# Technical Service Bulletin

## 46 Noise caused by stone between rear brake disc and splash shield

46 13 37 2029875/2 May 3, 2013. Supersedes Technical Service Bulletin Group 46 number 12-24 dated June 22, 2012 for reasons listed below.

Model(s)	Year	VIN Range	Vehicle-Specific Equipment
A8	2011	000001 - 999999	Not applicable
A8	2012	000001 - 033583	Not applicable

*Figure 1. Splash plates.*

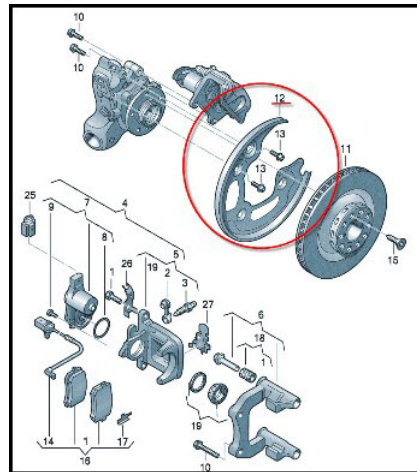
The customer may report hearing a loud screeching or grinding noise from the rear of vehicle when driving at low speeds. Upon inspection at the dealer, a very small stone or pebble is found stuck between the rear brake disc and splash plate. After removing the small stone, the noise is no longer present.

A splash plate optimized for this concern has been implemented in production vehicles.

1. Verify the customer concern matches the condition in this TSB.
2. Replace the left and right rear splash plates with the updated parts listed in the table below. These parts are also listed in ETKA for cars produced after April 2012.
